**LOUISIANA
POWER & LIGHT**

W3P83-2858
3-A1.01.04
3-A1.10

SUBJECT: Waterford SFS Unit 3 - Docket No. 50-382
HVAC Fire Dampers

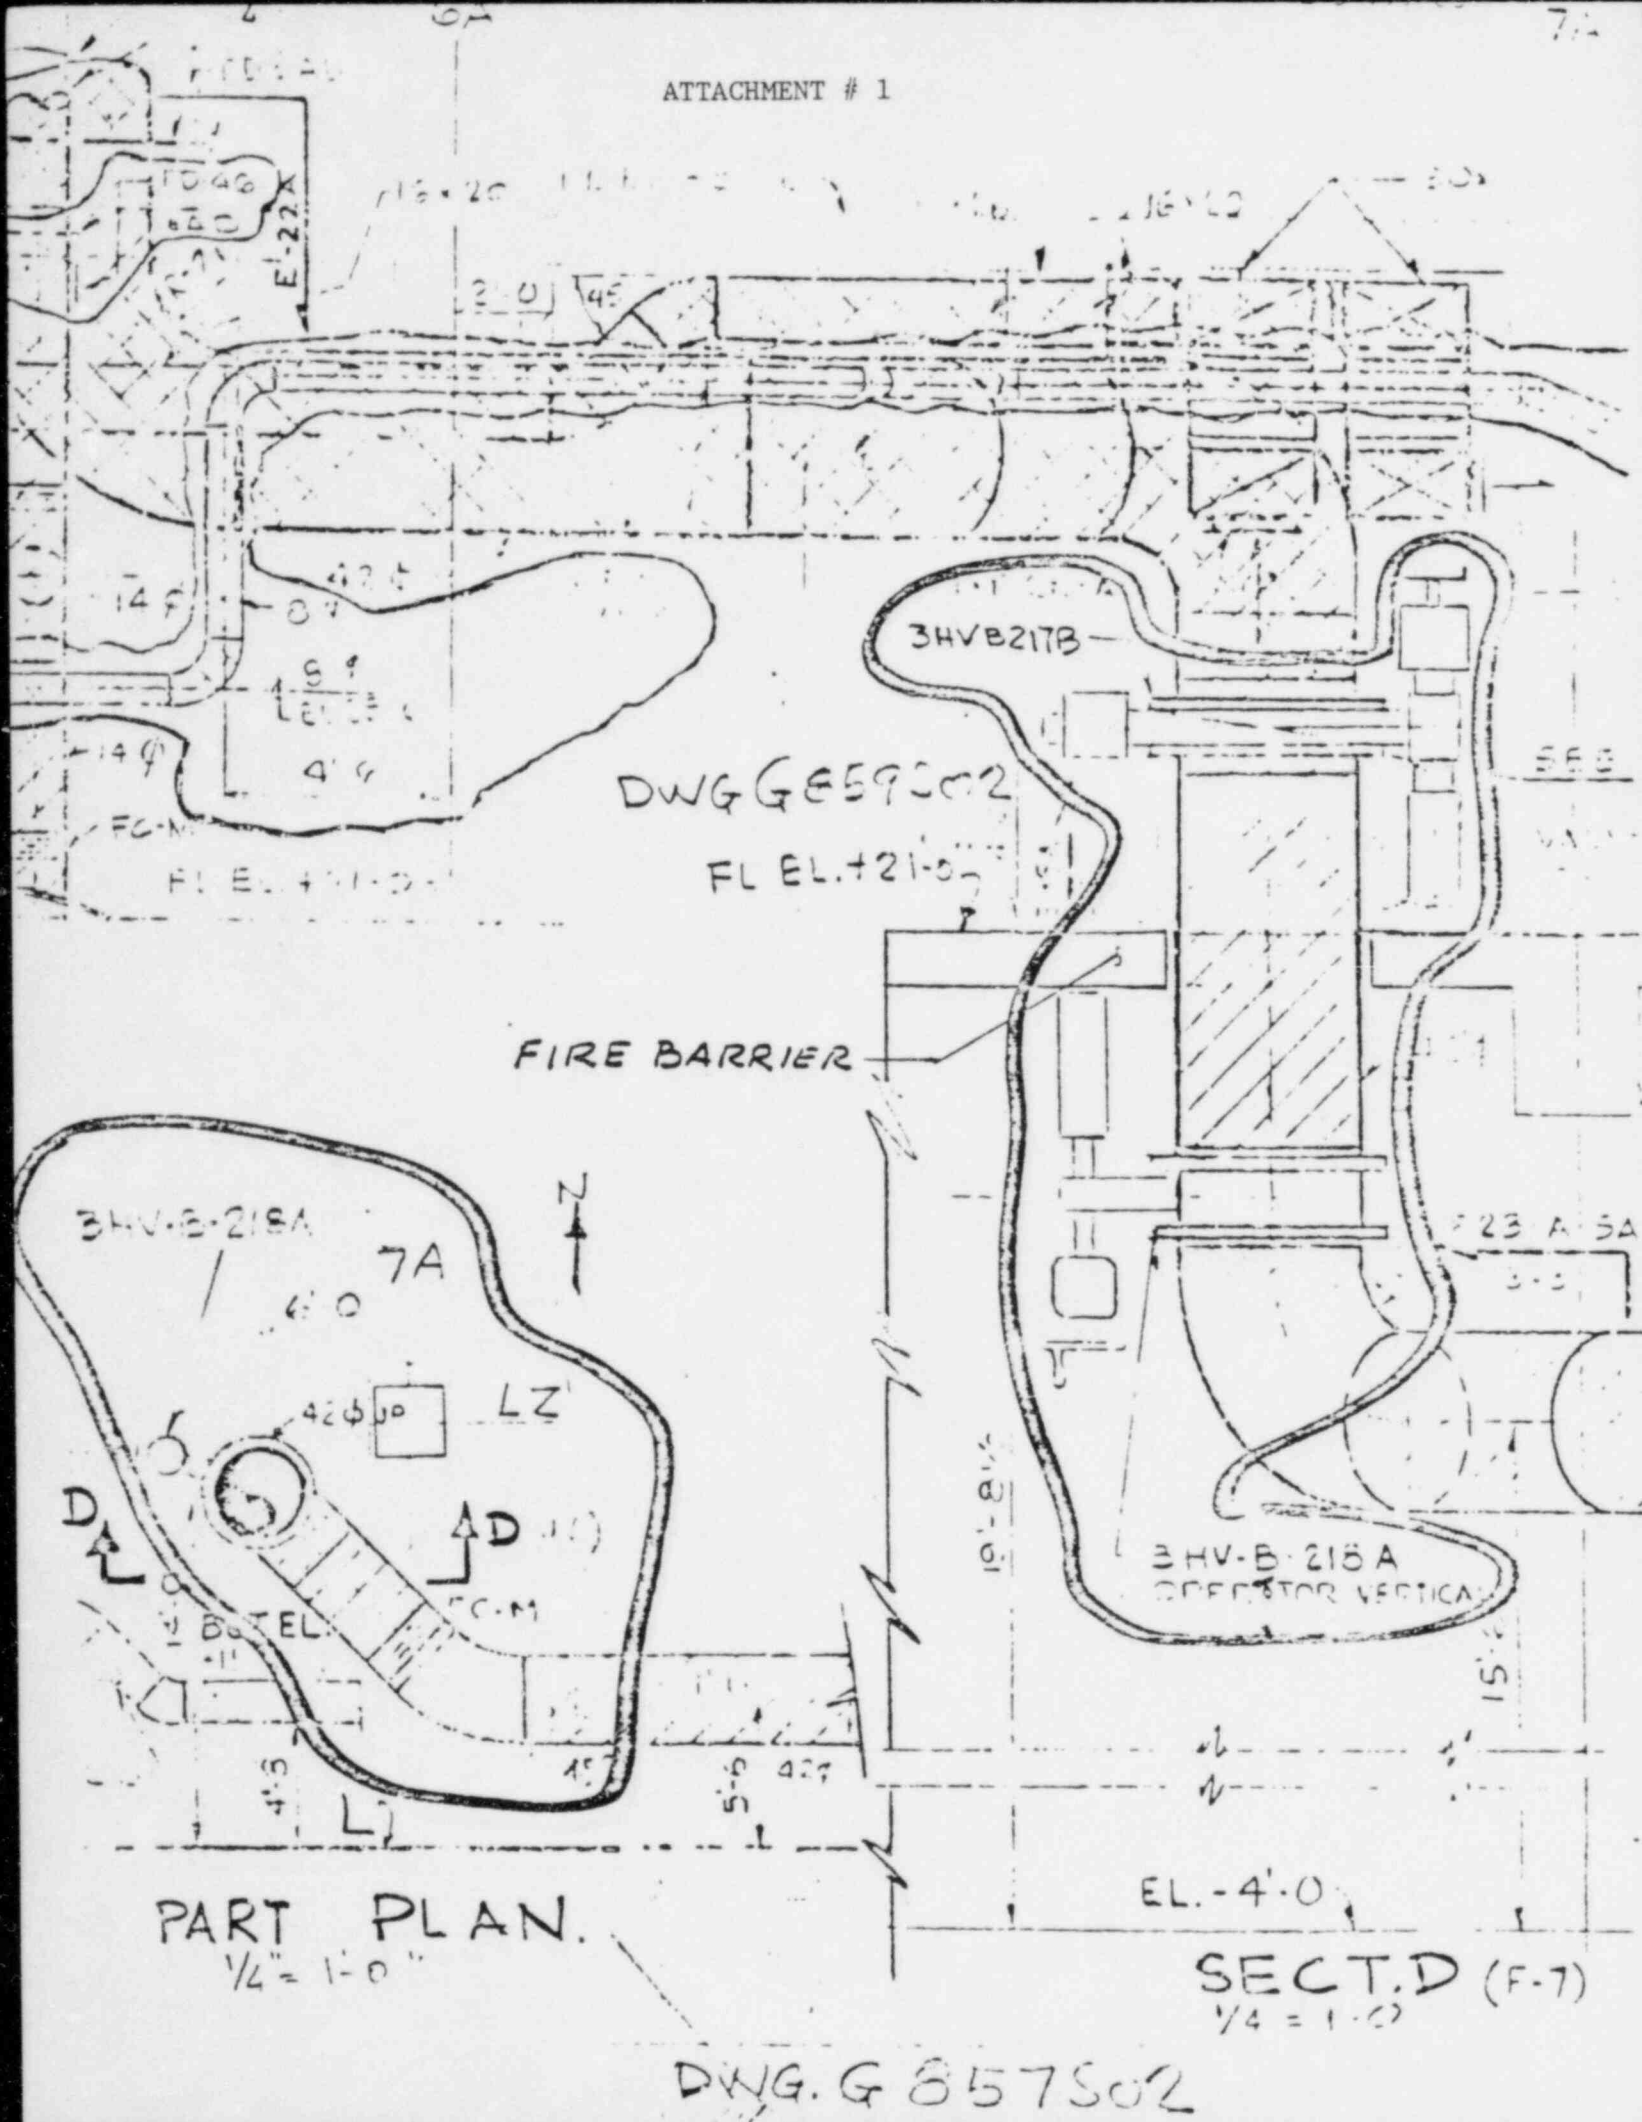
Attachment 1 shows the location of the fire barrier, as well as the 42" diameter butterfly valves on either side of the barrier. Each of these valves has a separate Microtemp thermal cutoff device associated with it. It is essential that the design prevent fire on one side of the barrier from being transferred to the other side. Our review of the Microtemp thermal cutoff concluded that its application would be simple, cost effective and at least equivalent to the fusible link on a fire damper.

Attachment 2 depicts the installation and operation of the Microtemp device. Basically, the thermal cutoff will open the electrical circuit to the solenoid valve when it senses a high temperature (165°F) in the duct. This will cut off the air supply to the air operated butterfly valve which, subsequently, will close and isolate the fire area. The butterfly valves are Nuclear Safety Class 3, Seismic Category I, and are 150 lb. rated. The valves are designed to fail closed. Inadvertent operation of the device during non-fire conditions, therefore, would not affect safe shutdown. In addition to the above, the section of ductwork between the two valves mentioned above will be provided with a one hour fire resistant barrier.
